**ALLENDALE CHARTER TOWNSHIP
PLANNING COMMISSION MEETING**

**RE: Marcusse Const. Offices – 5630 Lake Michigan Drive
Planning Commission Review**

To: Mr. Kevin Yeomans – Fresh Coast Planning
Date: August 31, 2022
From: Jeff Brinks, PE- Venture Engineering, PLLC
RE: **Marcusse Office Building- Allendale Township**

PROPOSED SITE DEVELOPMENT PLANS FOR:
Marcusse Construction Offices
5630 LAKE MICHIGAN DRIVE
NW 1/4, SECTION 26, TOWN 7 NORTH, RANGE 14 WEST
ALLENDALE TOWNSHIP, OTTAWA COUNTY, MI

**Marcusse Const. Offices - 5630 Lake Michigan Dr.
SITE LAYOUT PLAN**

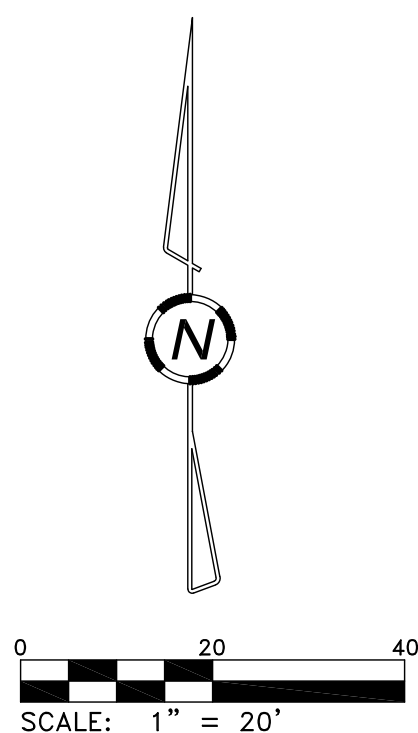
9. All references to MDOT standards shall be updated to the latest 2020 edition instead of the 2012 edition.
- a. Sheet C1 STANDARD PAVEMENT SECTION notes the use of 2012 edition.

- 9. The reference to the 2012 MDOT specs has been revised to 2020.
- 11. We have obtained the record plans for the sanitary lateral from the Township and have revised the plans accordingly

CB 125 - 4' DIA. OUTLET STRUCTURE
NOT TO SCALE

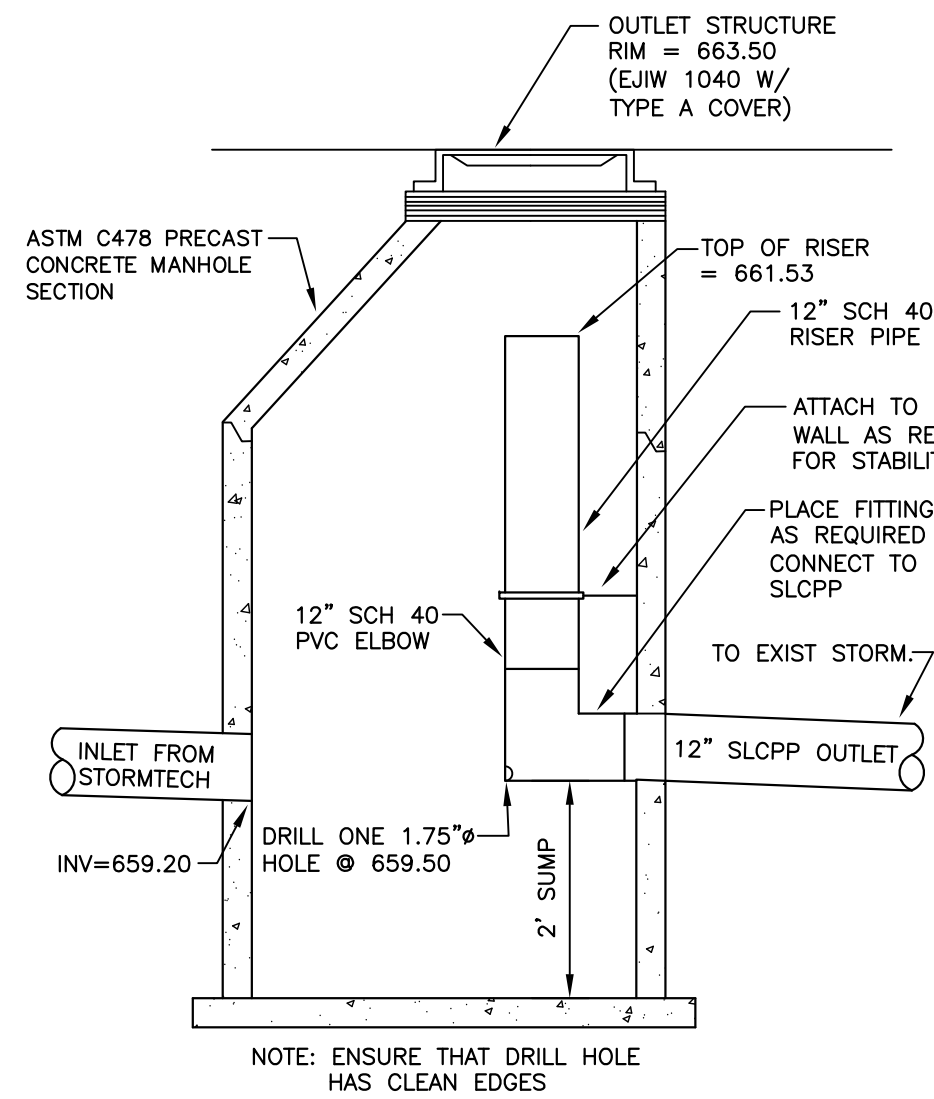
- b. CB 125 detail appears to have a typo for the pipe invert elevation (559.20) that should be corrected.
 - c. CB 125 appears to be located underneath proposed landscaping area on the north side of the parking lot. Revise landscaping area or relocate CB to prevent maintenance issues.

- 7a. We have included storm water calculation with this submittal.
- 7b. The typo has been corrected.
- 7c. The sidewalk and landscaping has been revised such that maintenance for CB 125 should not be an issue.
